TEXAS HISTORICAL COMMISSION

Texas Main Street

**Design Services: Case Studies from Main
Street Cities**

Baxter's on Main, Bastrop

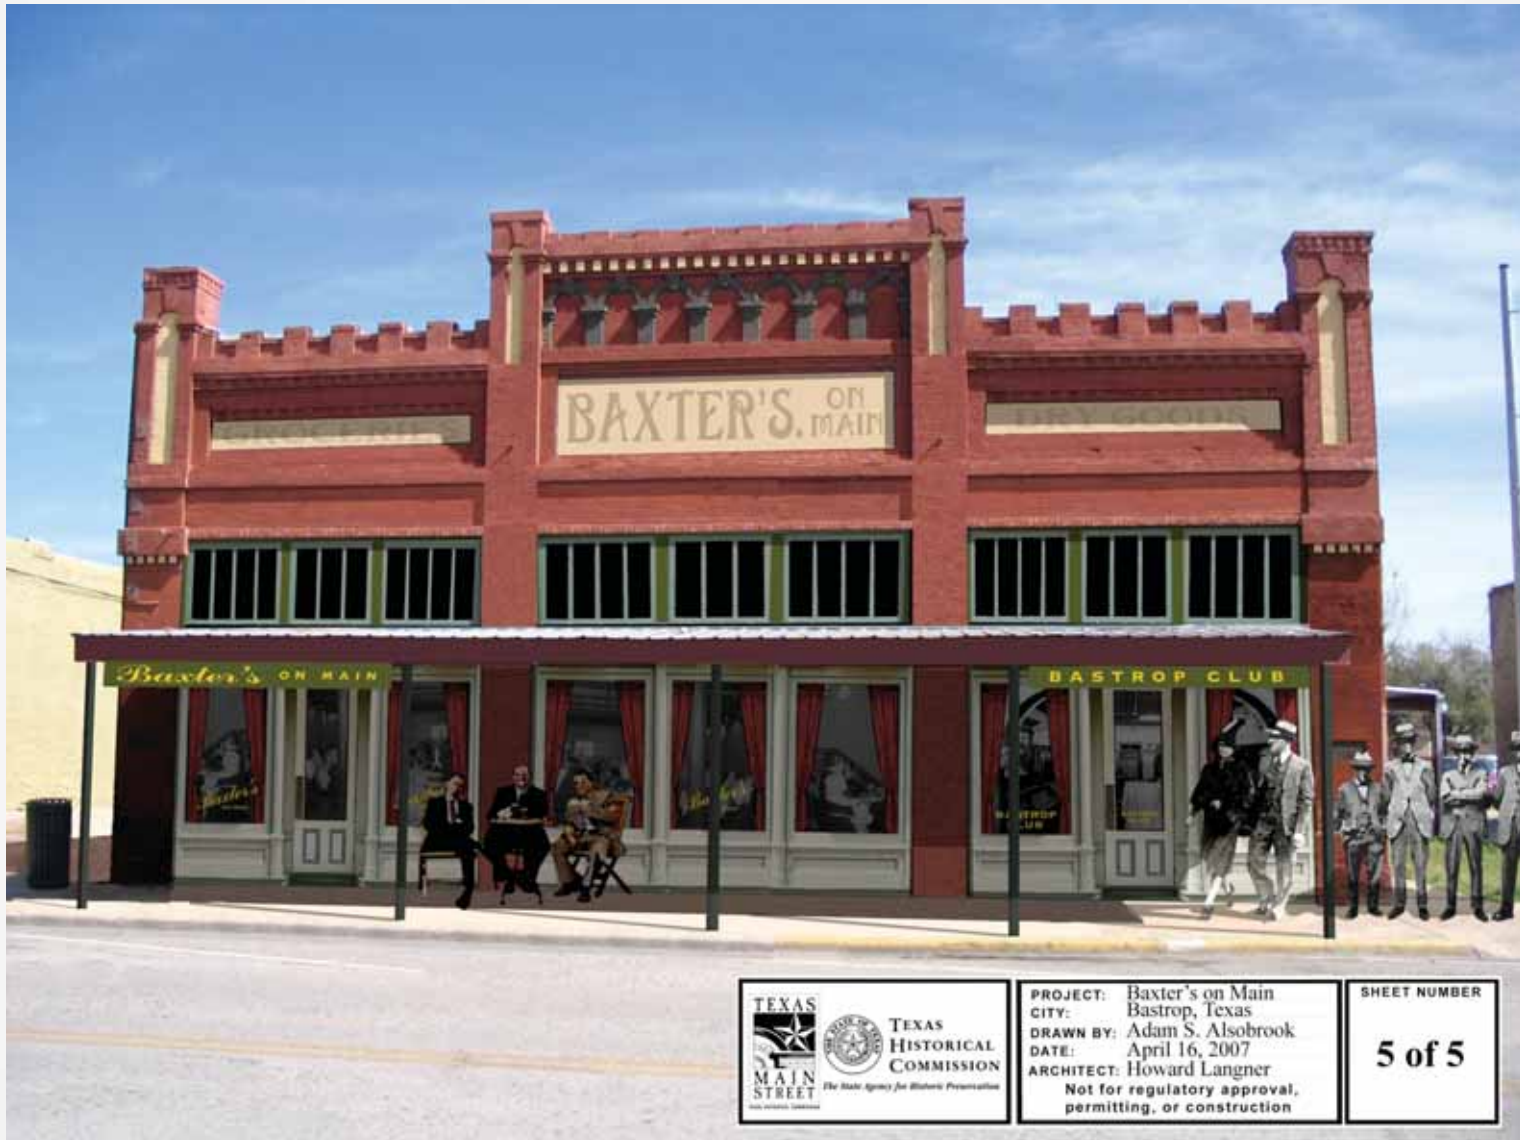
- replace bricked-in portion of façade with wood storefront
- restore transom windows above the canopy
- replace existing columns supporting the canopy with more slender columns
- consider signage that reinterprets the “dry goods” and “groceries” signs that are shown in historic photographs

Rendering of 1416 Sam Houston, Huntsville, July 2005

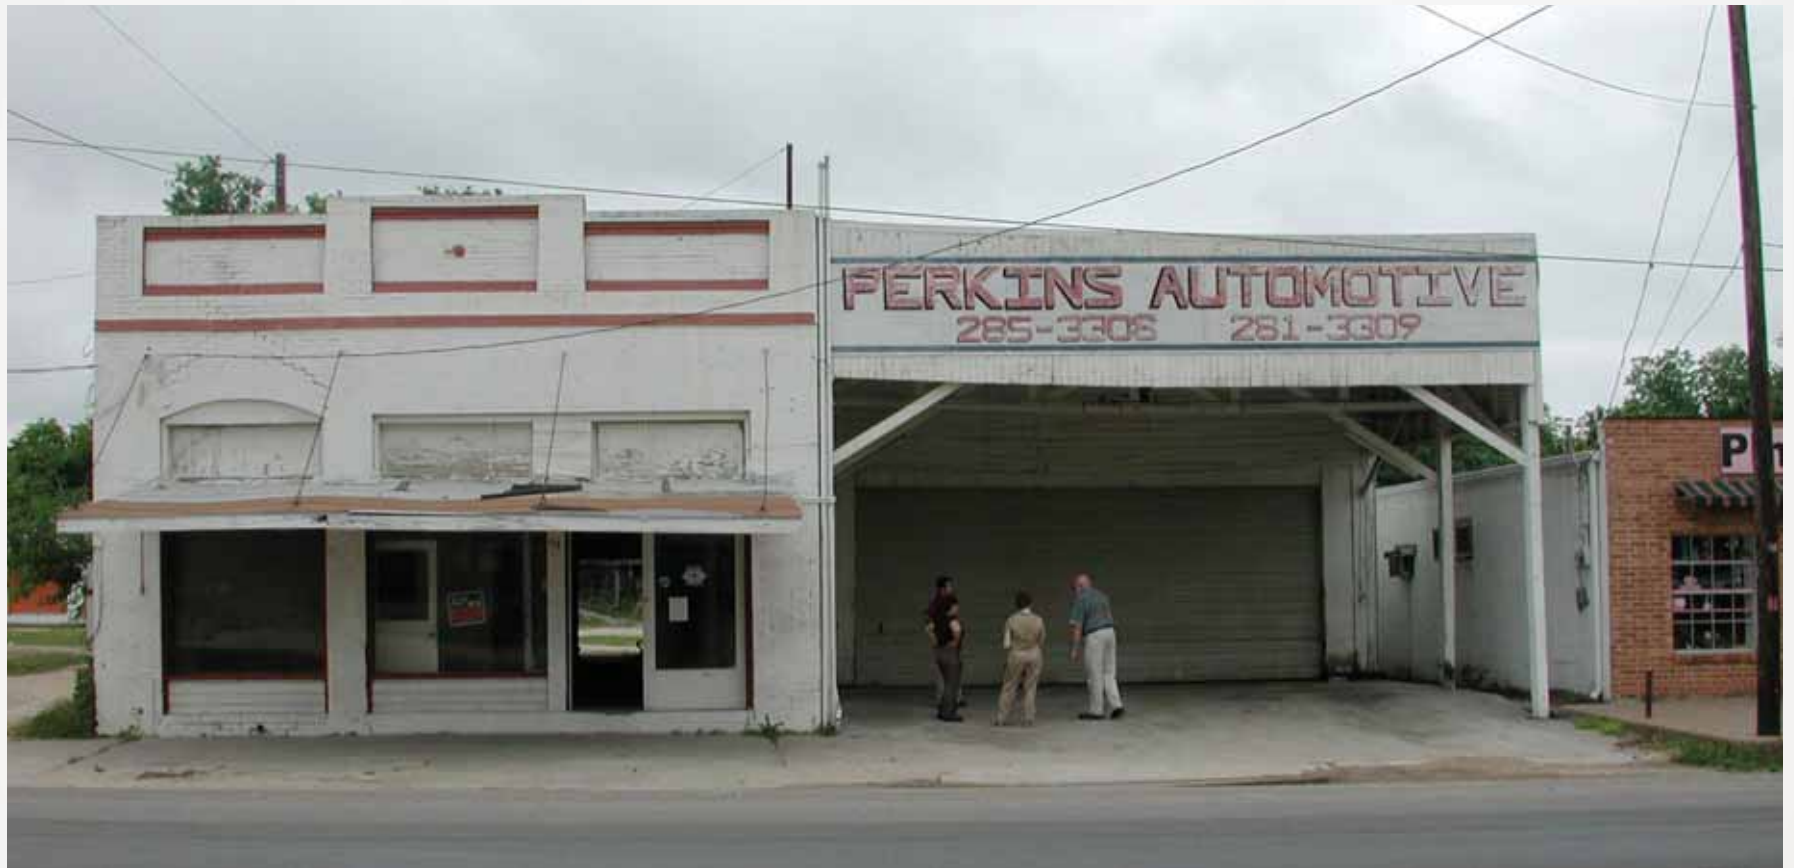
- Paint building to accent architectural details and to call attention to the art deco style of the building
- Subtle base color may be accented with two shades of blue-green, with a maroon strip painted at the base of the building

Times Building, Farmersville, March 2004

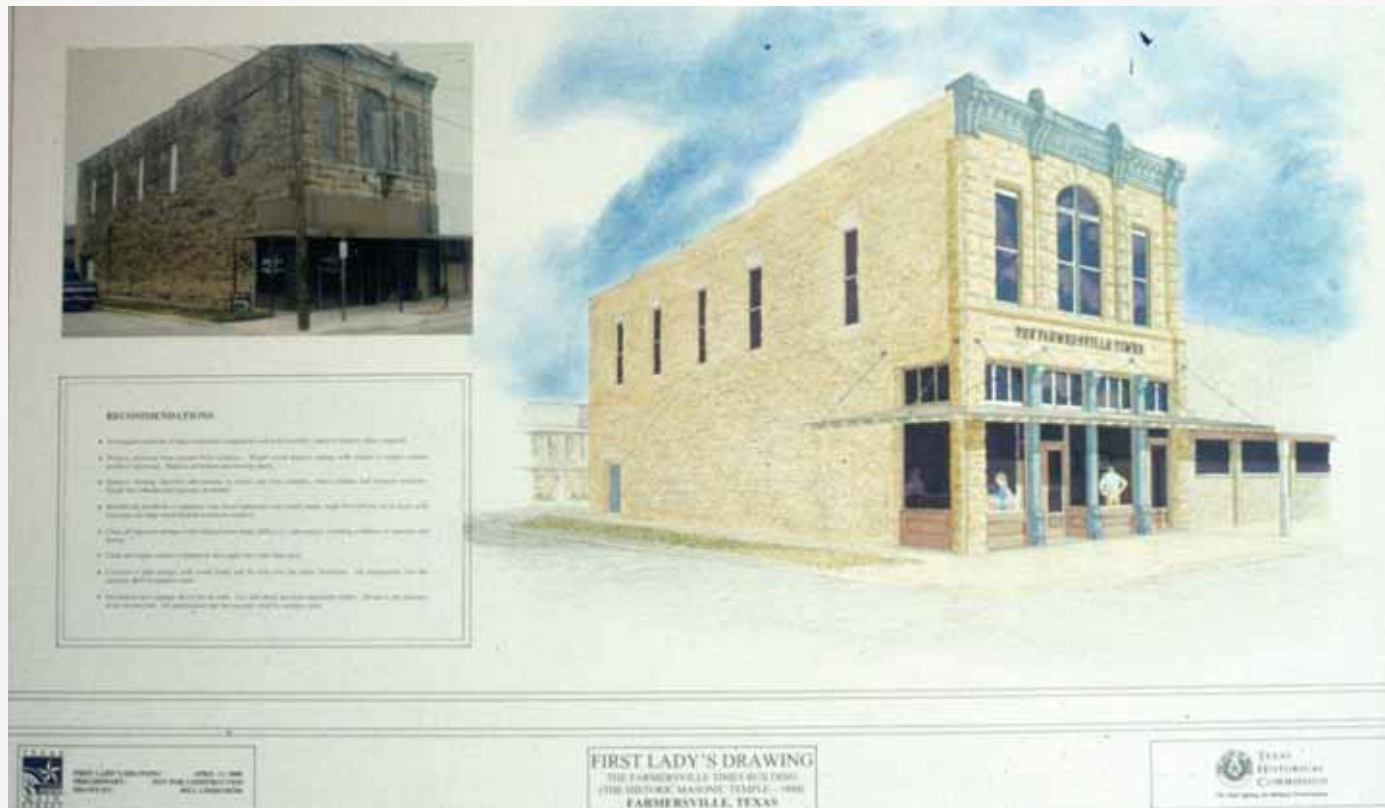
- remove slipcover over lower portion of façade and gently clean stone to restore original appearance
- restore transom and second story windows
- rebuild storefront including columns, bulkheads, and canopy

200 S. Washington, Pilot Point

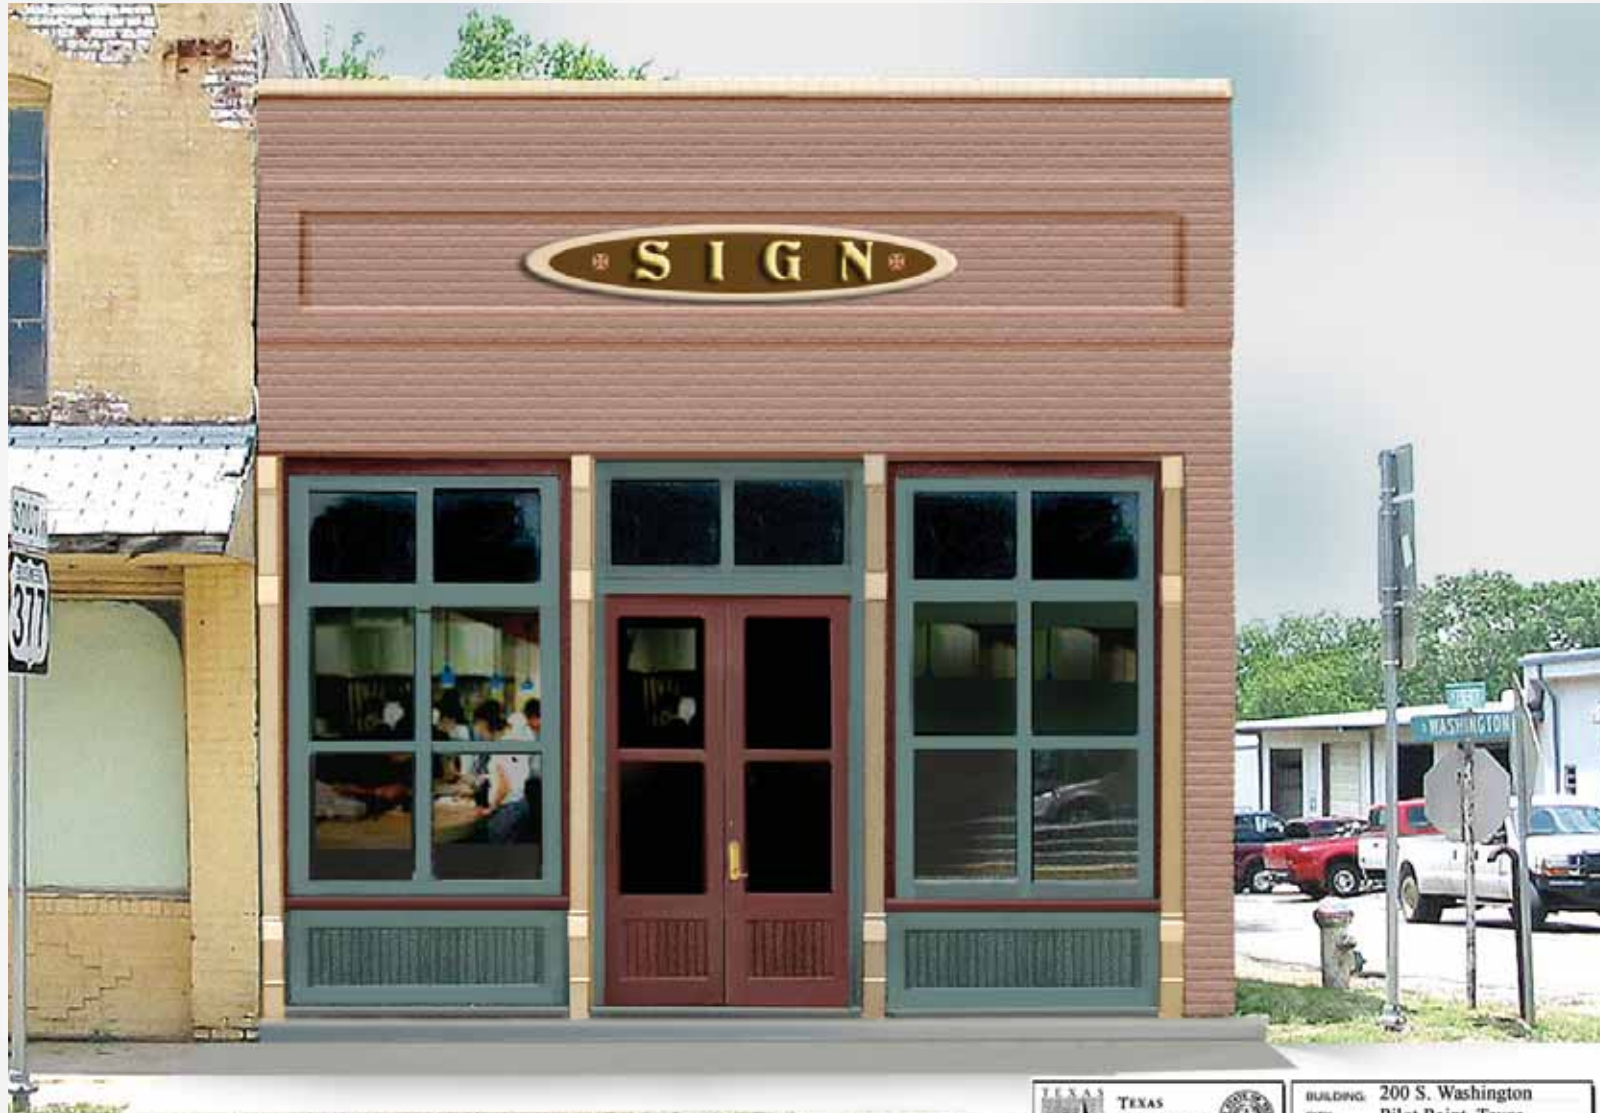
- gently clean brick to remove white paint, and rebuild portion of parapet that has collapsed
- replace broken panes of glass in storefront
- accent columns and door and window frames with contrasting paint colors
